FARRAGUT VISUAL RESOURCES REVIEW BOARD
AGENDA

MEMORANDUM

TO: Farragut Visual Resources Review Board
FROM: Bart Hose, Assist. Community Development Director
SUBJECT: Scheduled Meeting - Tuesday, December 17, 2024, at 6:00 p.m.

TACO BELL
11217 KINGSTON PIKE
KNOXVILLE, TN

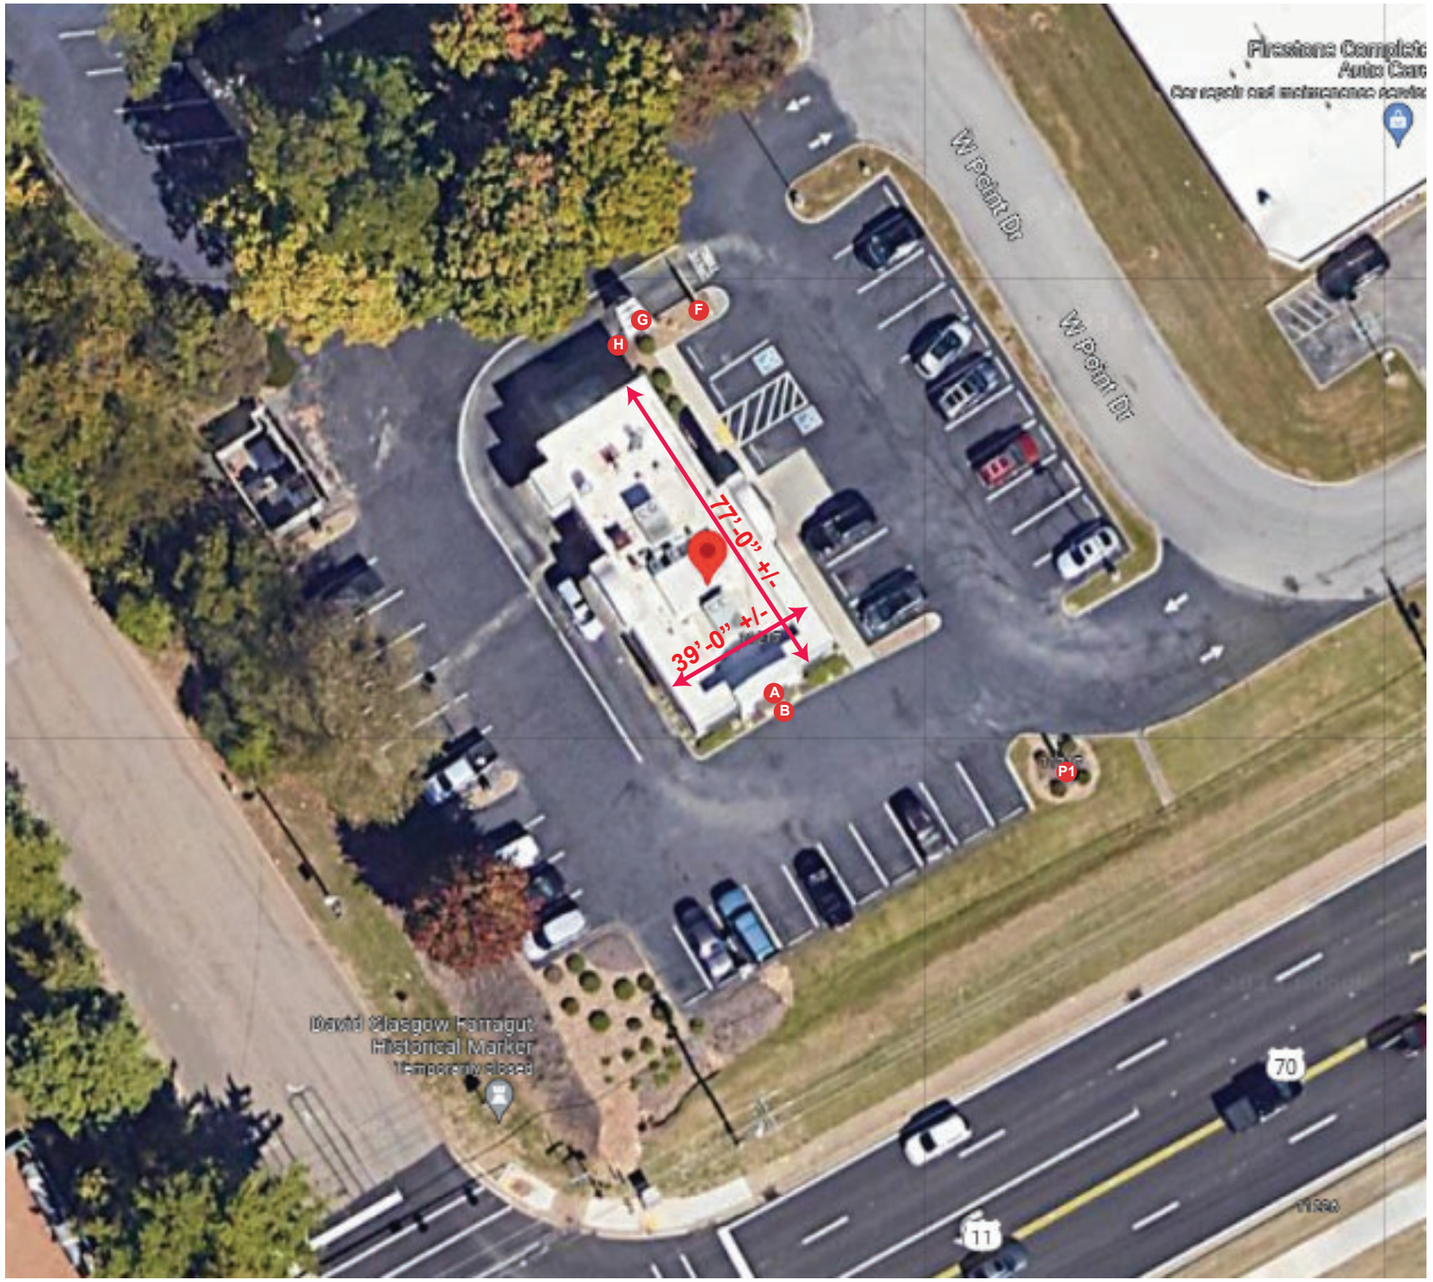
As part of this permit, this light cannot exceed 4000k. In addition, the light must be mounted, directed, and shielded to eliminate glare and light spill.

UPLIGHTING FOR NON-ILLUMINATED LETTER SET.
LIGHTING TO BE INSTALLED ONTO EXISTING CANOPY

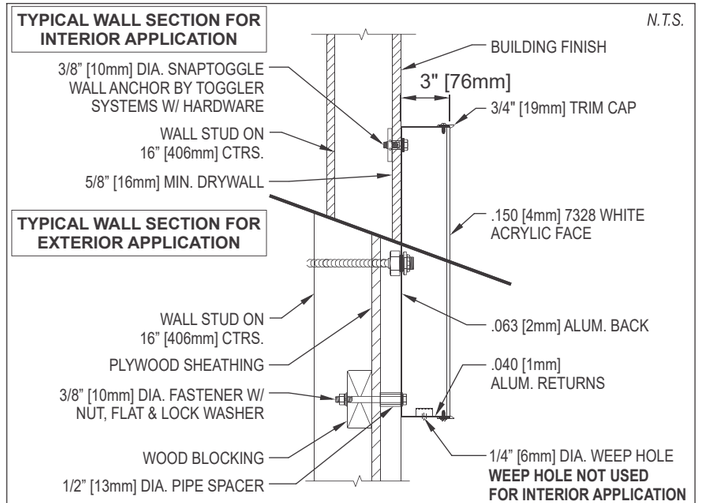
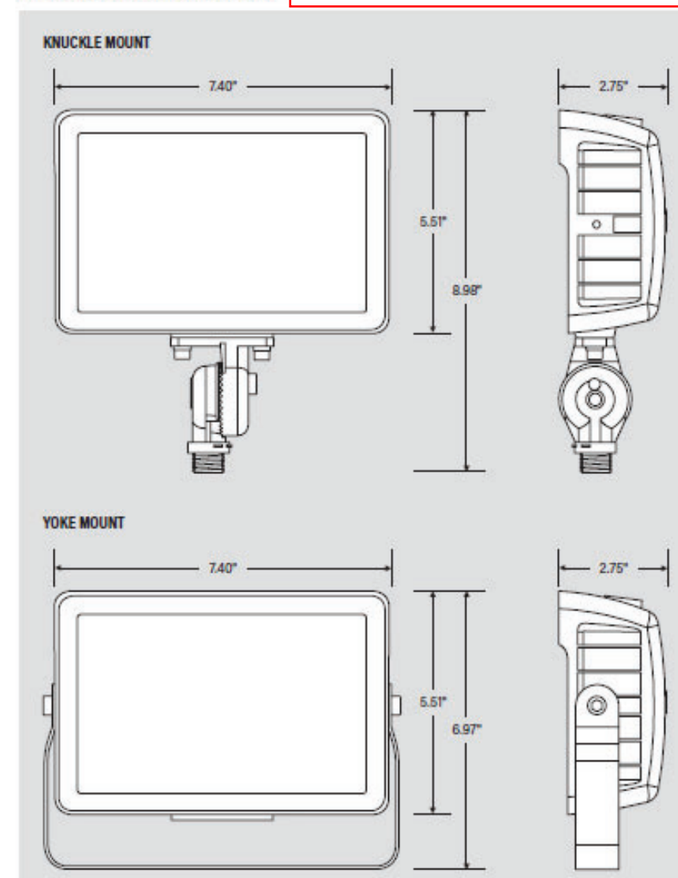
As part of this permit, this light cannot exceed 4000k. In addition, the light must be mounted, directed, and shielded to eliminate glare and light spill.

Not permitted to exceed 4000K

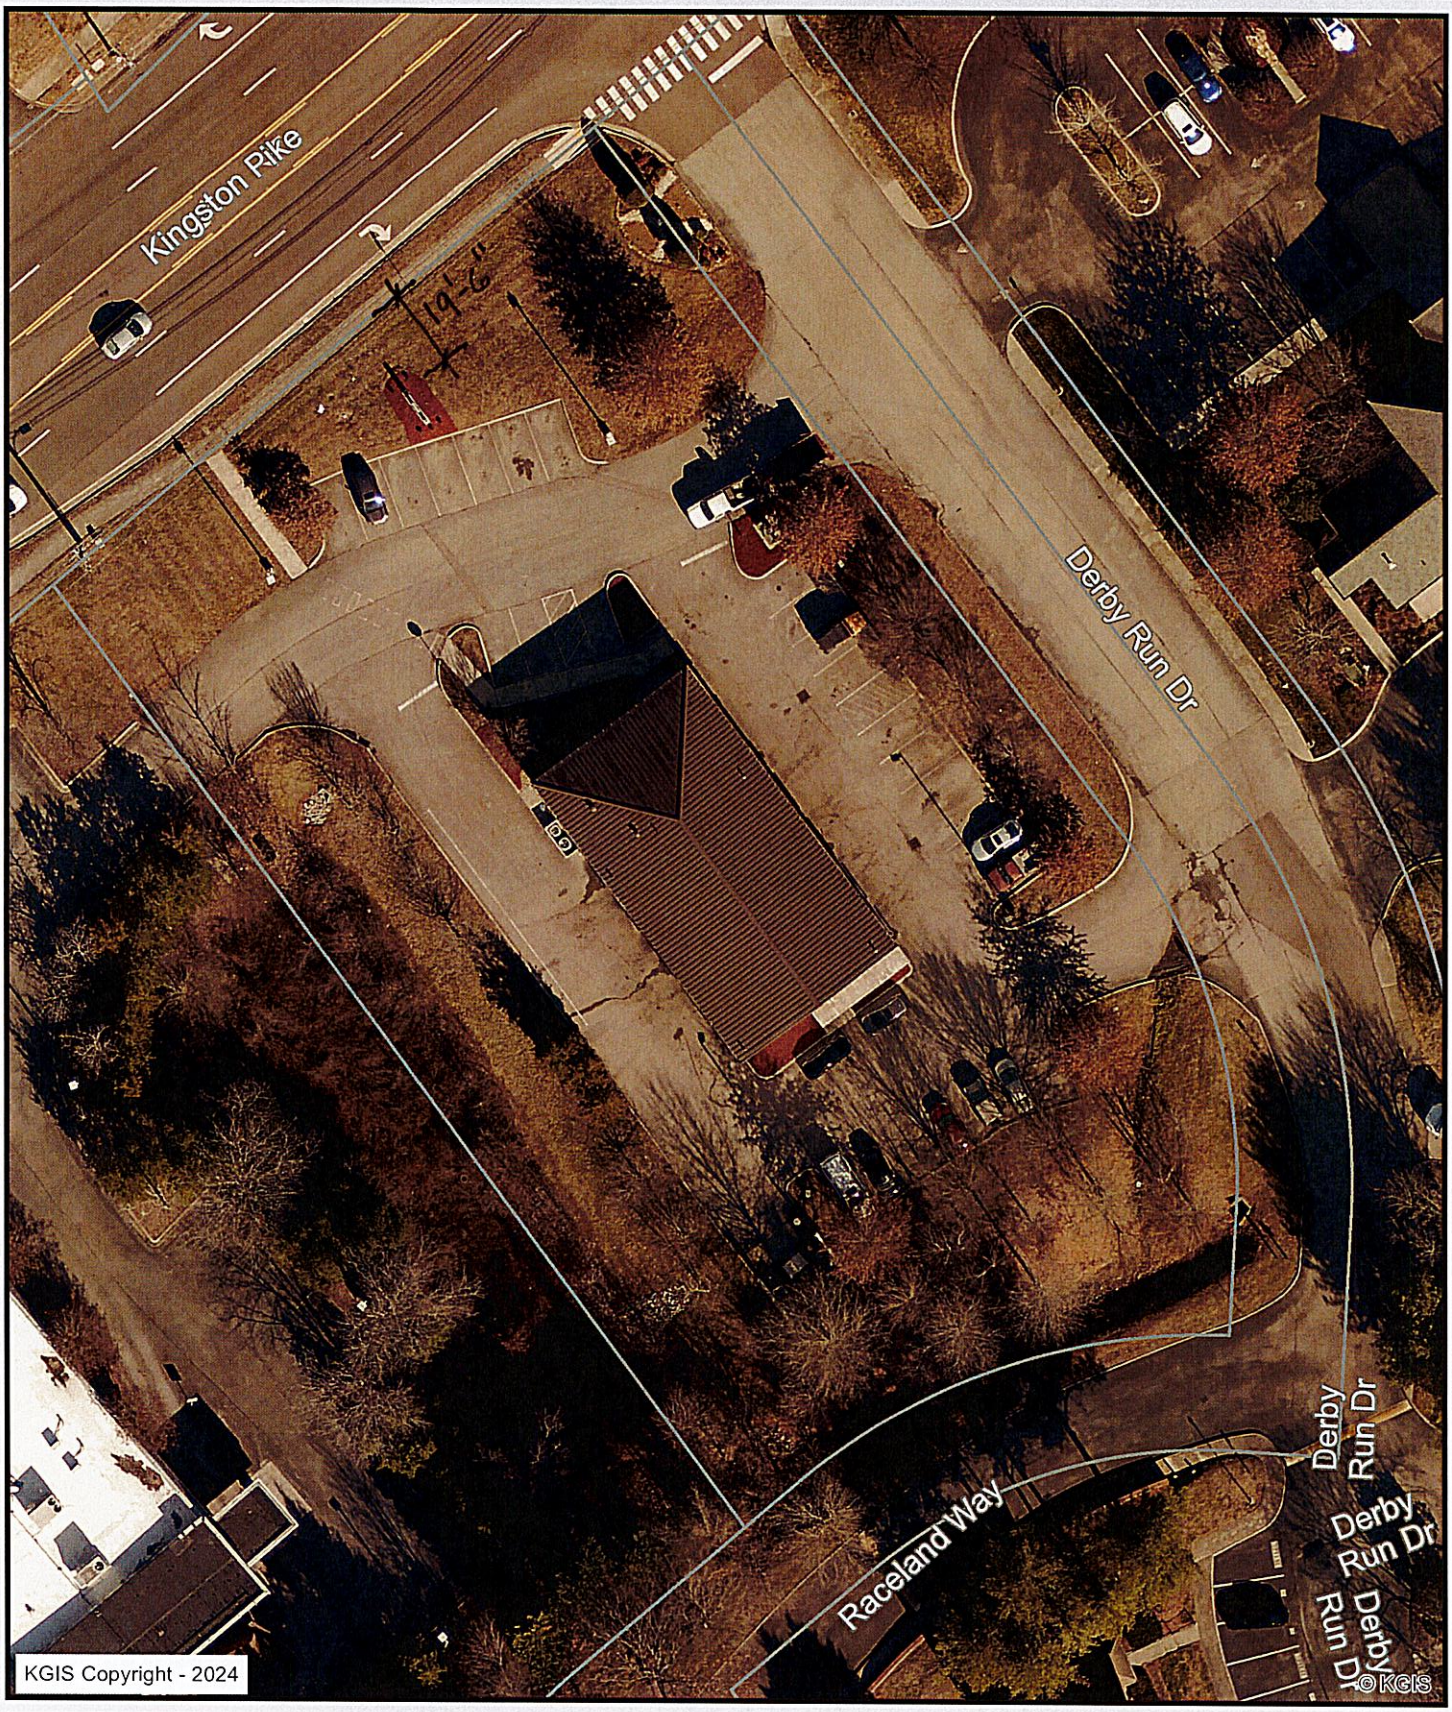
b) CarFix – Located at 11926 Kingston Pike
Primary Ground Mounted Sign located off Kingston Pike.
Carfix is requesting approval to reface the permanent ground mounted sign at their facility located at 11926 Kingston Pike.

The request involves refacing an existing sign with no additional changes. The staff can recommend approval.

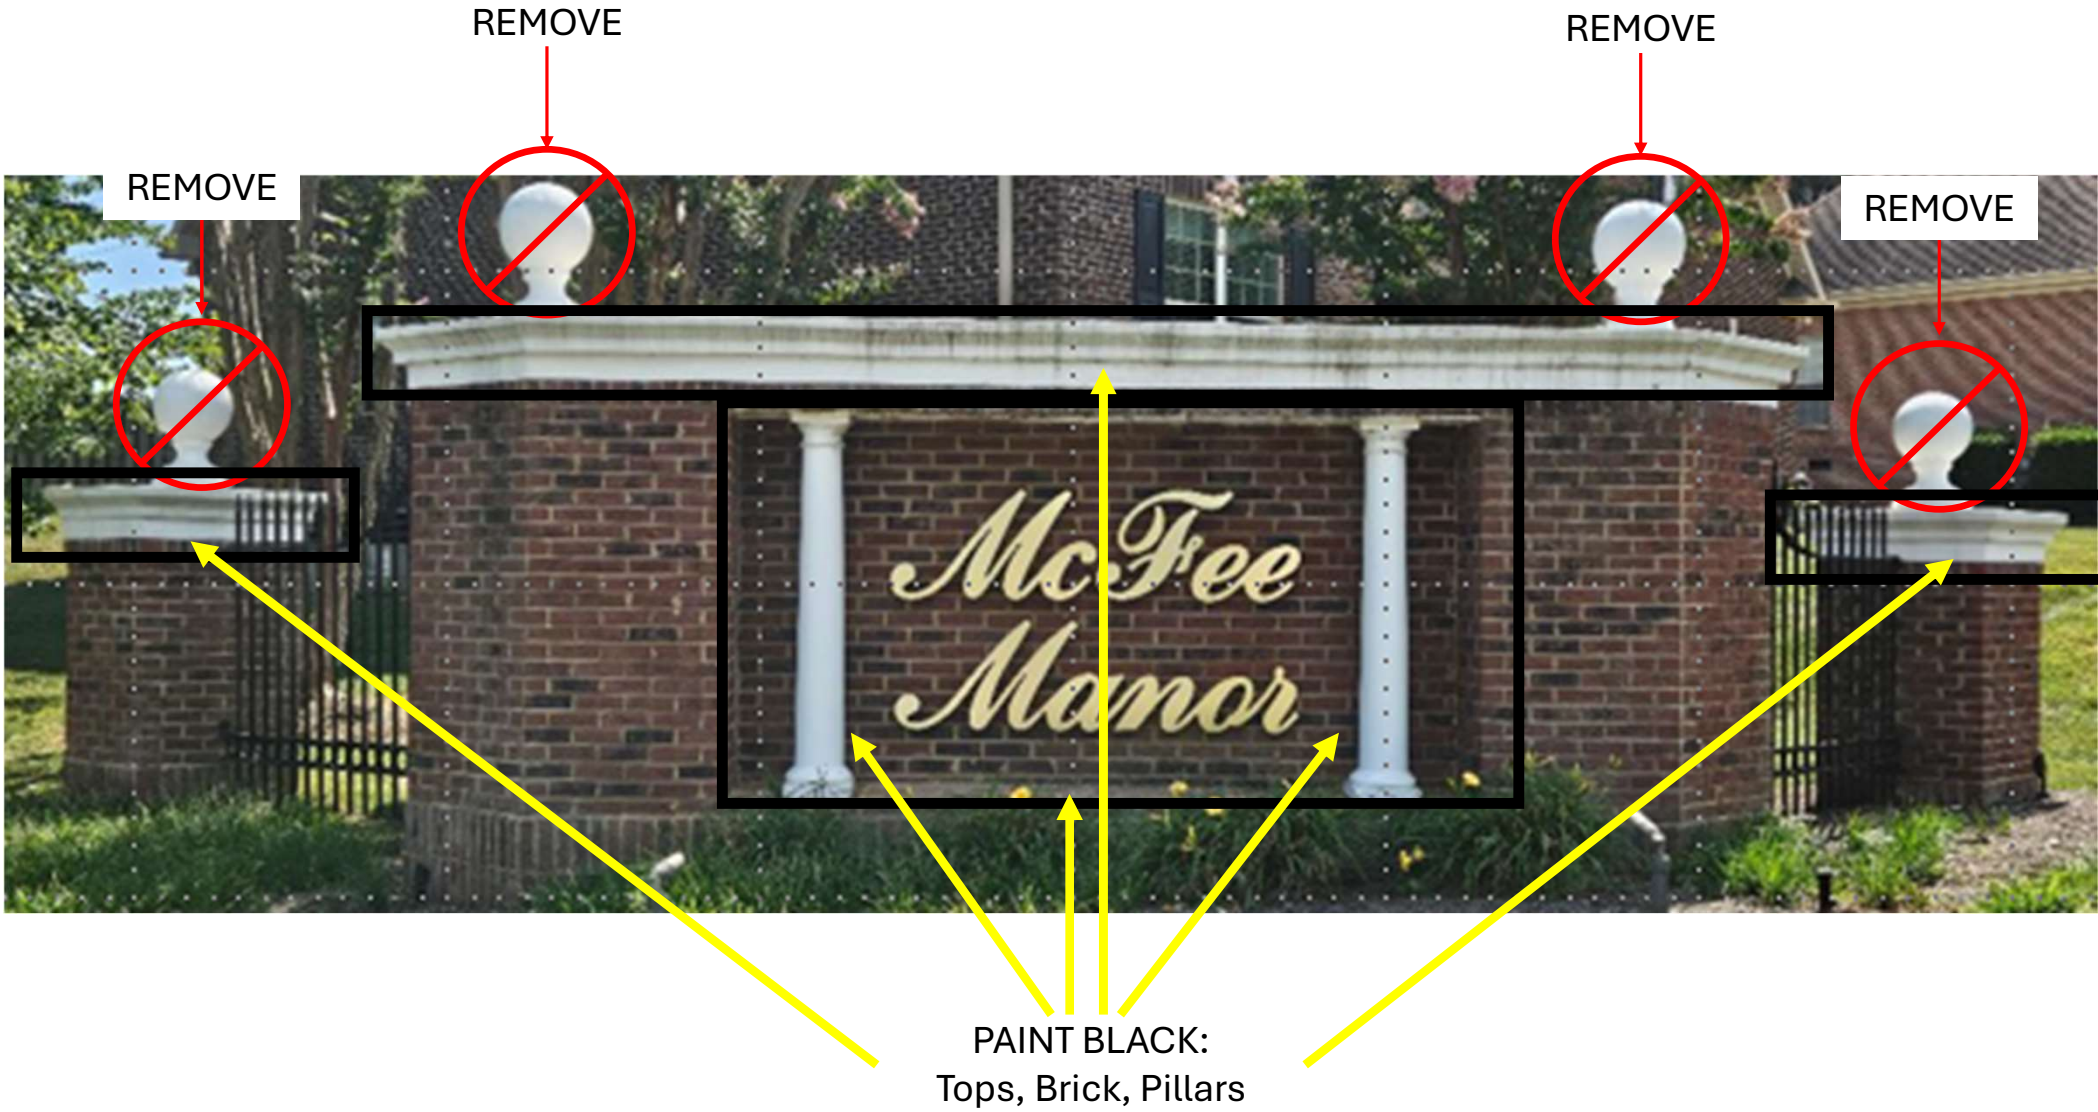
c) McFee Manor Subdivision – Located of McFee Road
Permanent Subdivision Sign located off McFee Road and Providence Glen Lane.
McFee Manor Subdivision is requesting approval to renovate and upgrade their subdivision entrance sign located at the corner of McFee Road and Providence Glen Lane.

The McFee Manor Subdivision HOA is requesting approval to renovate and update their existing entrance sign. The project involves repairing or replacing some elements and painting other elements to update the look of the existing sign. The staff can recommend approval.

TP1 - Glen Abbey Blvd. Frontage

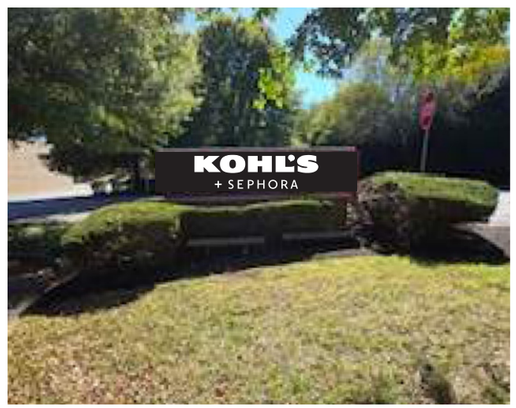
e) Kohl's – Sephora, Glen Abbey Blvd. Frontage– Located at 11930 Kingston Pike
Primary Ground Mounted Sign located off Glen Abbey Boulevard.
Kohl's - Sephora is requesting approval to reface and upgrade the permanent ground mounted sign along the Glen Abbey Boulevard frontage at their facility located at 11930 Kingston Pike.

Kohl's + Sephora is requesting approval to reface the existing Kohl's monument ground sign located along Glen Abbey Blvd. No other changes to the sign are proposed and the landscaping and external lighting for the sign are in place. The previously noted addressing issue does not apply to this sign because the property is not addressed off Glen Abbey Blvd., and including a Kingston Pike address on the sign could cause confusion. The staff can recommend approval.
